Change Order

PROJECT: (Name and address)
16751-Trenton High School Cafetorium

CHANGE ORDER INFORMATION:
Change Order Number: 007
Date: 07/13/2021

Miscellaneous changes per attached Change Order proposals:

PLUMBING-RFI #61
 SKETCH

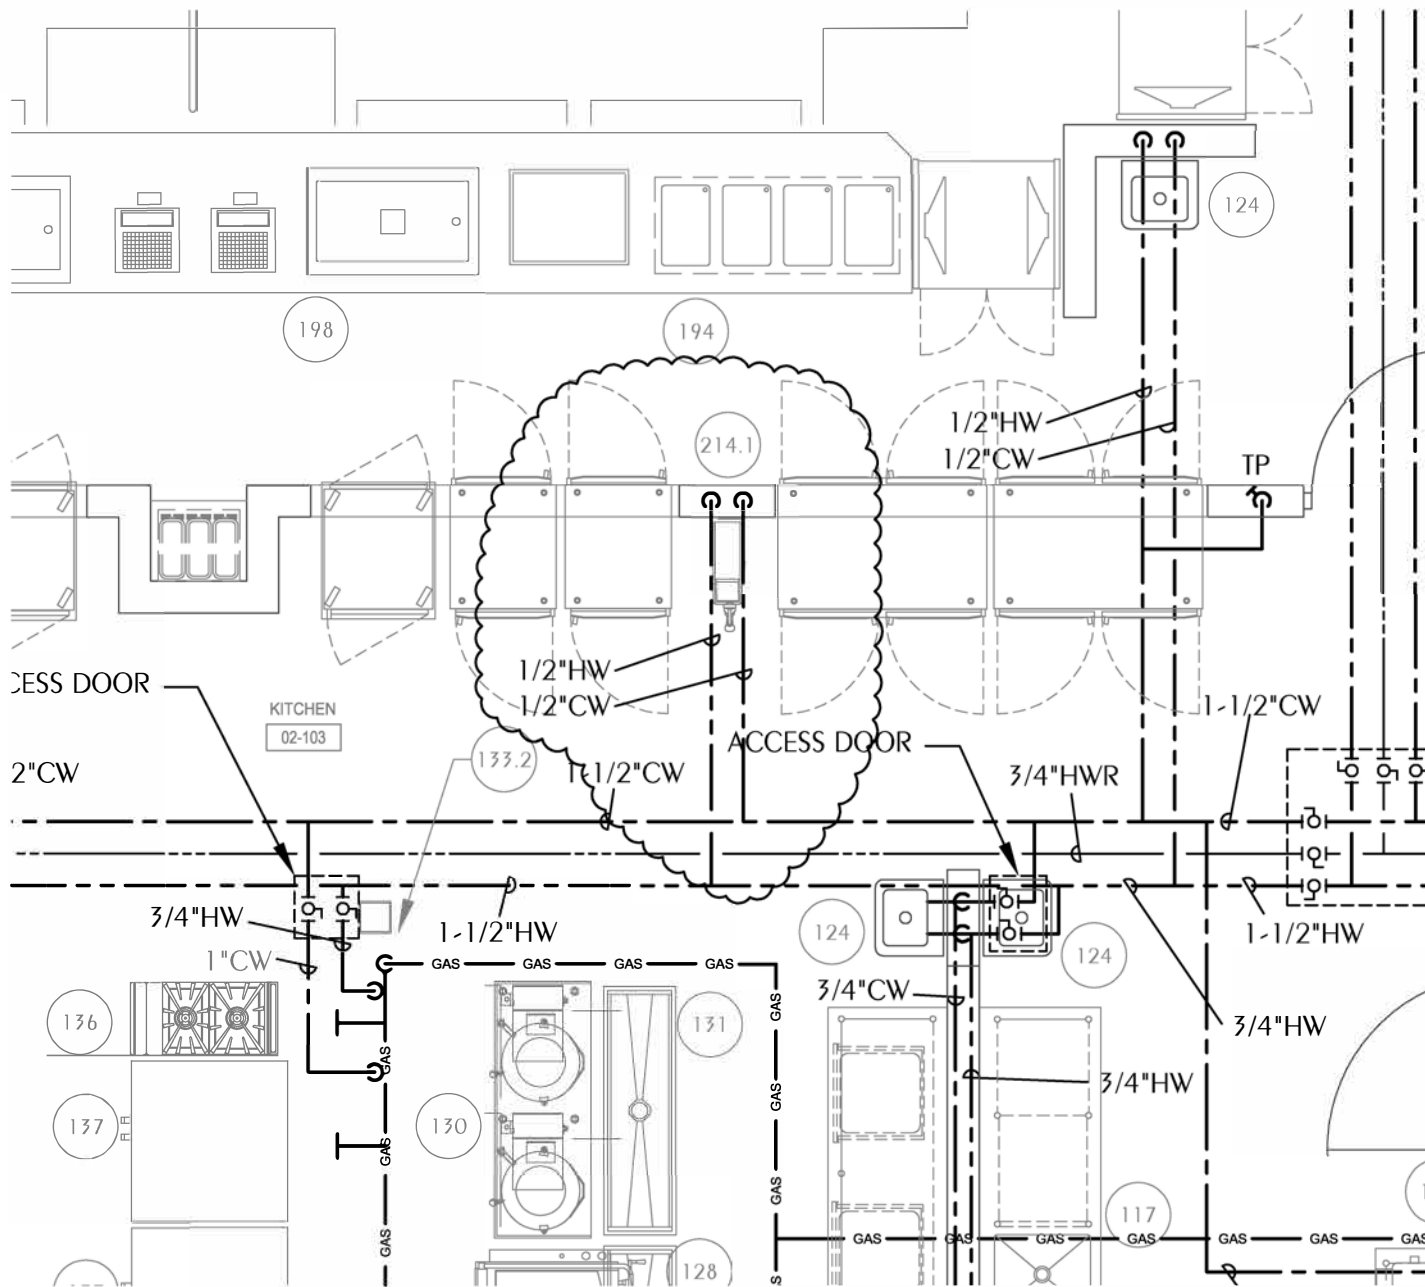
On page P2.2 dated April 15, 2020, the equipment schedule shows a Hose Reel with sprayer 214, however, there is no piping shown on P2.2 for this hose. Please provide piping detail.

Engineer's Response: Attached sketch (RFI 61 WATER PIPING SKETCH.pdf) shows connection of 1/2" hot and cold water to food service equipment # 214.1 - Hose Reel.

SHEET NUMBER:
E6.0

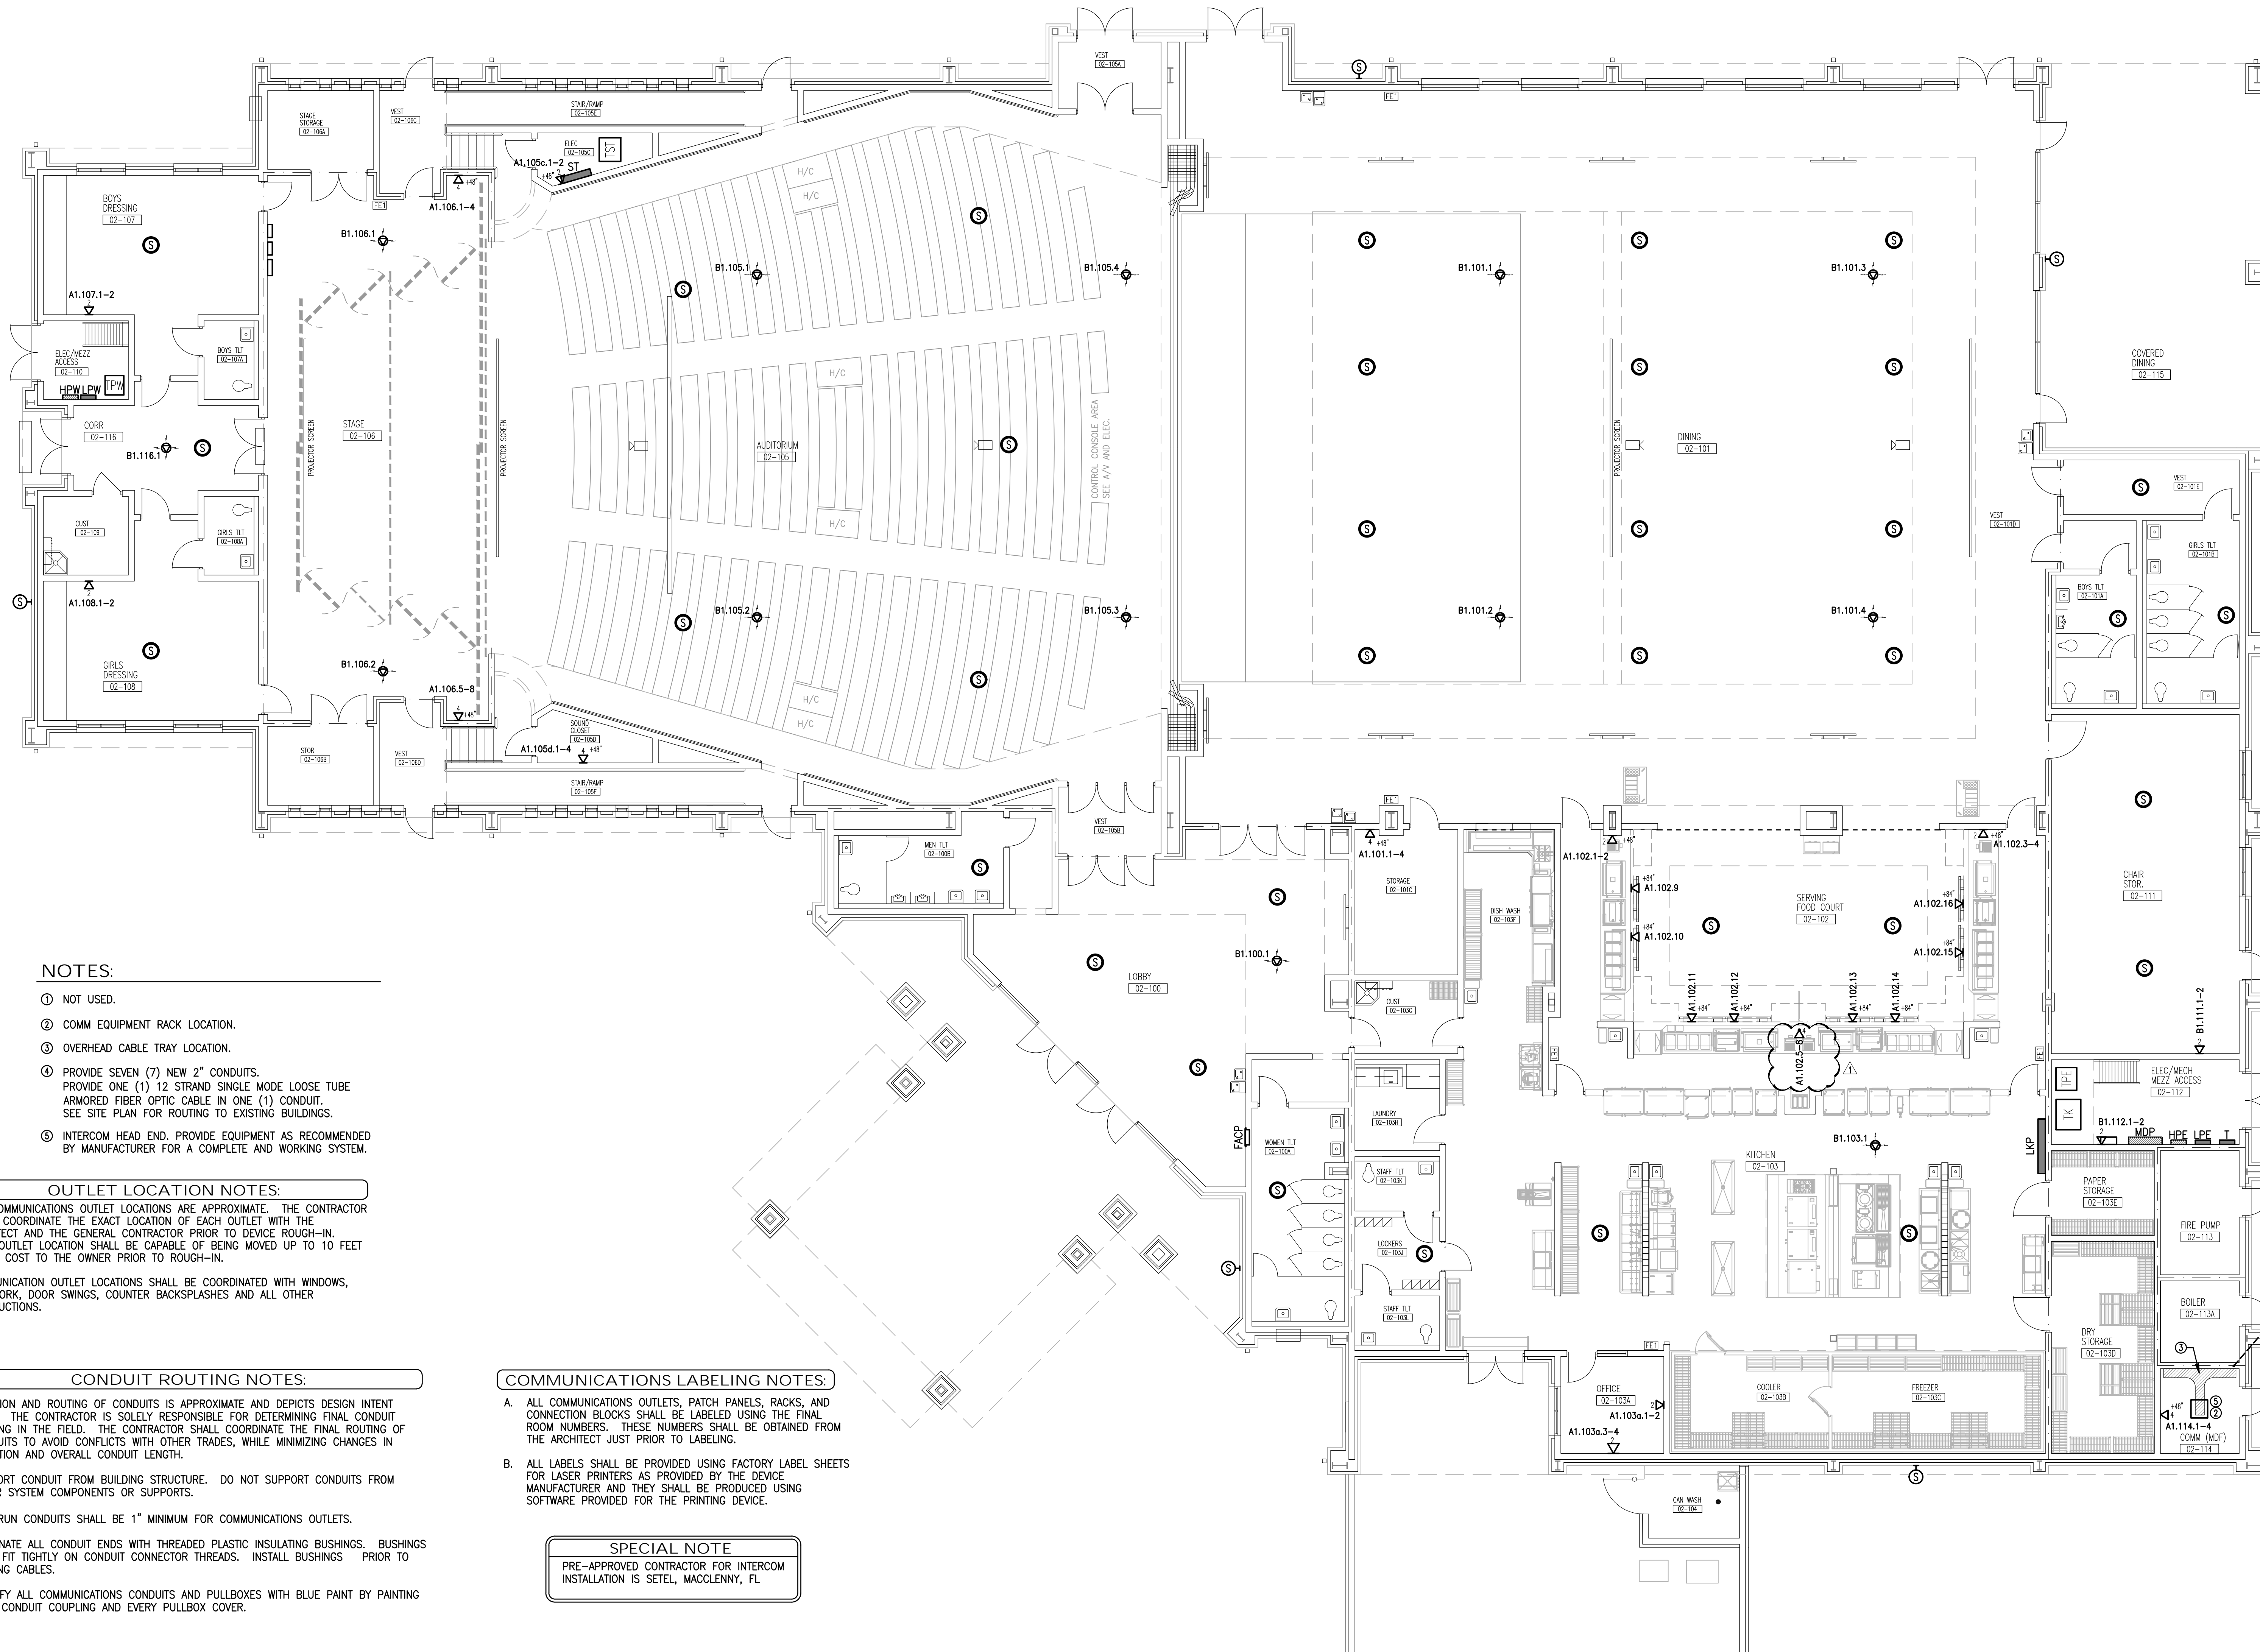
1. On sheet E6.0 dated April 15, 2020, a floor box is shown in the middle of the kitchen without any panel/circuit designation. Does this box require power or is it for communications only?
2. On sheet E1.1 dated April 15, 2020, please indicate where the floor outlet stub-ups(detailed) are to be installed.

Delete floor box and provide two Floor Outlet Stub-Ups (i.e. "tombstone" J-boxes) in its place, one duplex/power, and one for data. Typical ¾" power conduit to LKP, and 1" data conduit to COMM rack, per attached revised electrical sheets

SHEET NUMBER:
E3.0

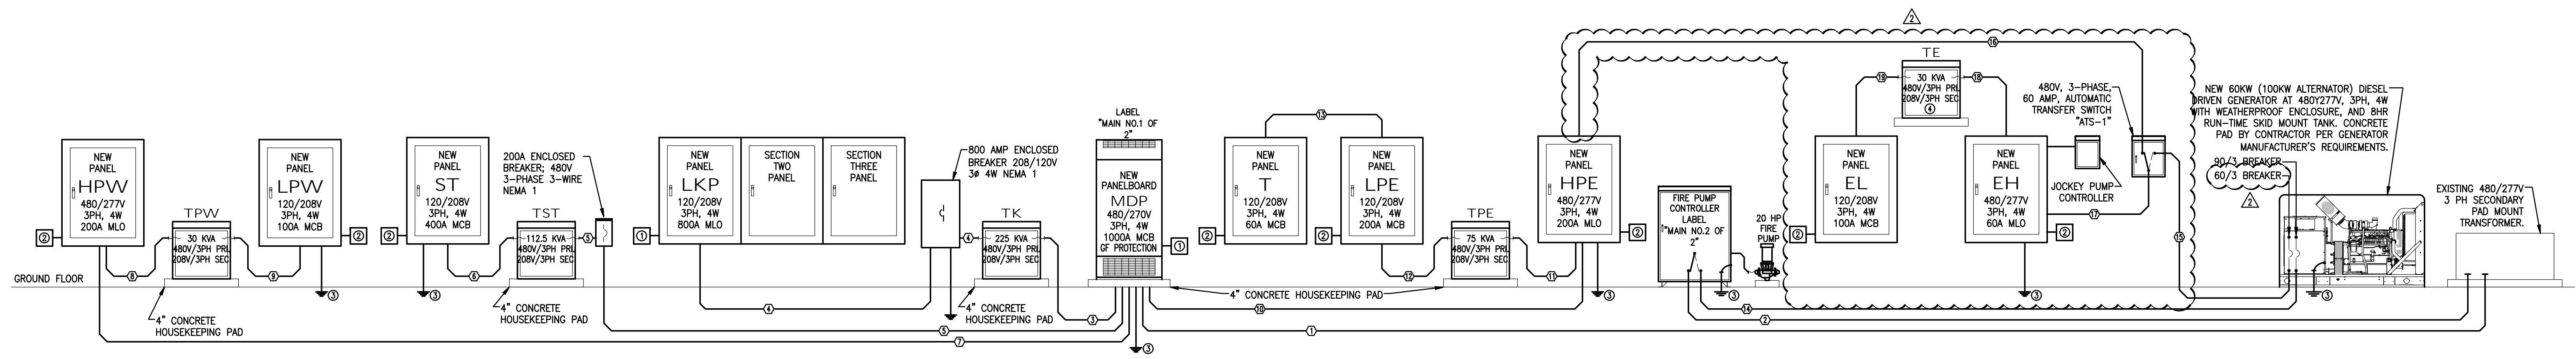
- 1) Revise electrical requirements to put Cooler/Freezer unit on emergency generator power, per attached revised electrical sheets E1.1, E3.0, E3.1, E4.0, E4.1, E4.2, E4.3 and E4.4 (8 sheets total).
-

SHEET NUMBER:
 Bid Drawings S1.0

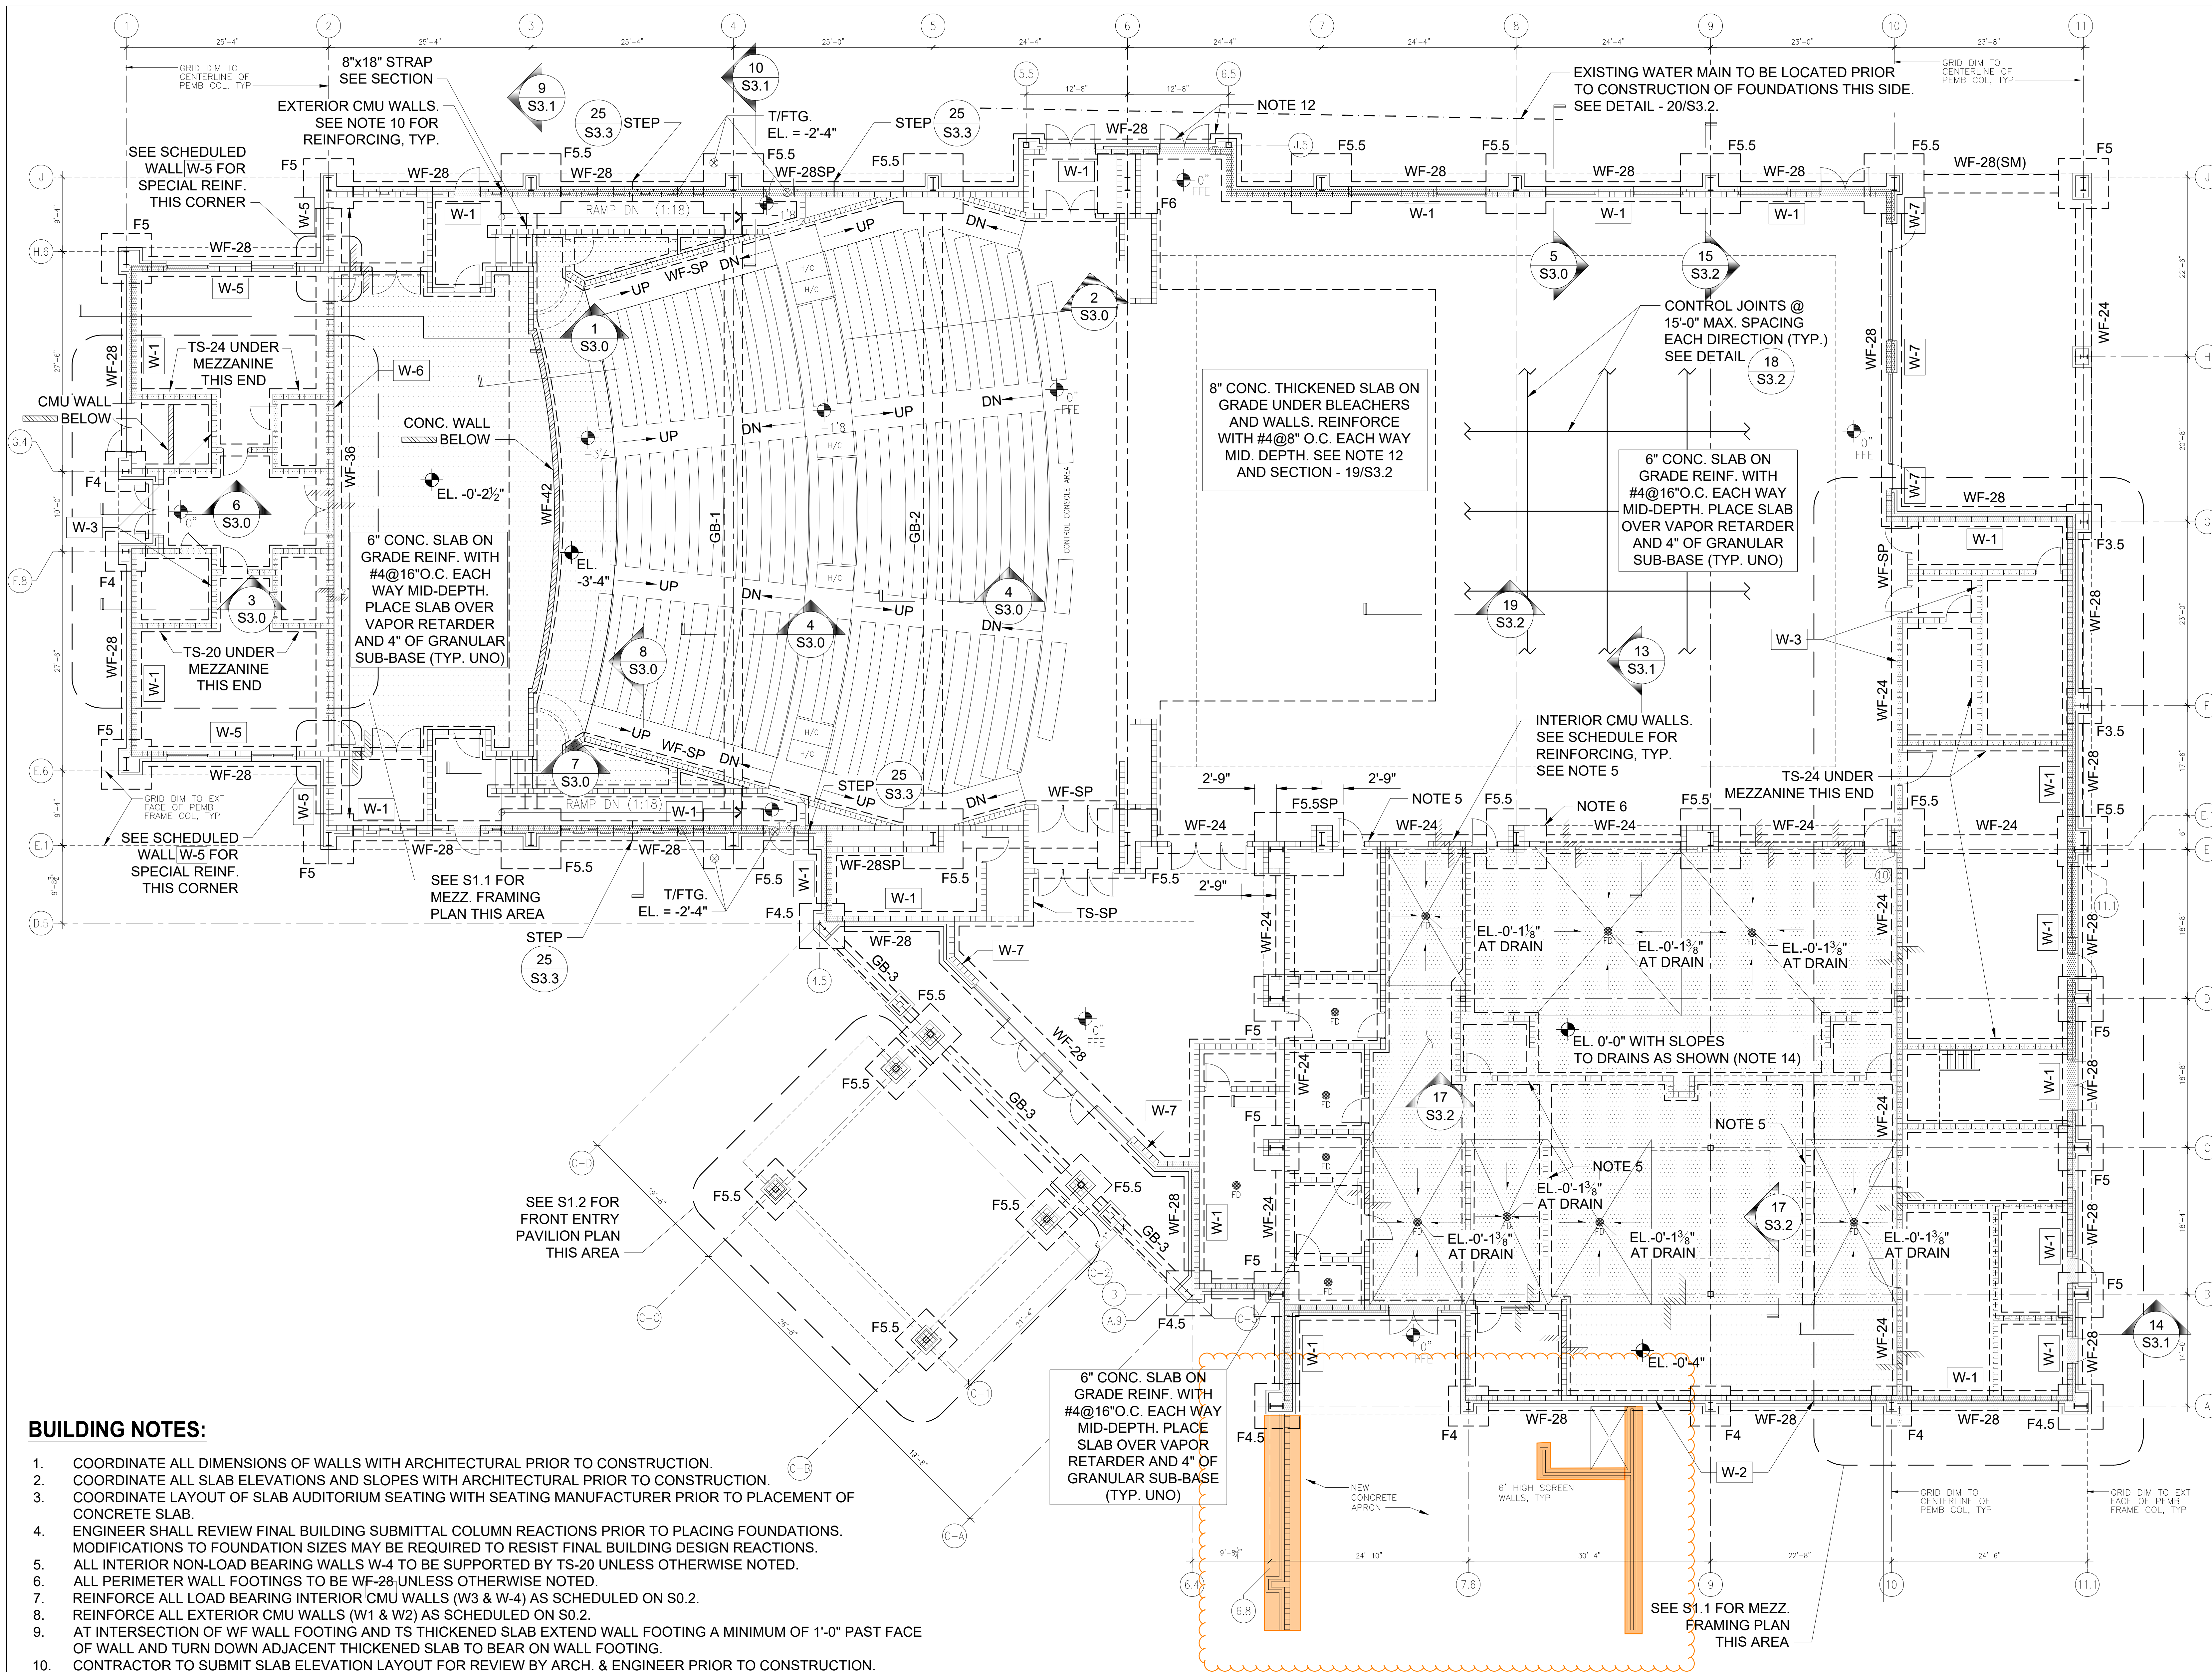
I believe it is a workability issue. They can take out the “unsuitable” clay-rich materials. But when they try replacing them with clayey sands and it rains, they are just gonna not get density and have to remove and replace again and again. The limerock will be easier to place and compact. But that is means and methods, time and money.

Our plan is to over excavate 2', similar to the exterior walls, and install clean compacted archer fill. If you feel that is not acceptable, please let me know.

Proceed as required. When submitting COP for this work, please provide back-up including:
Geotech confirmation of soil unsuitability,
and truck tickets for any haul & fill material.
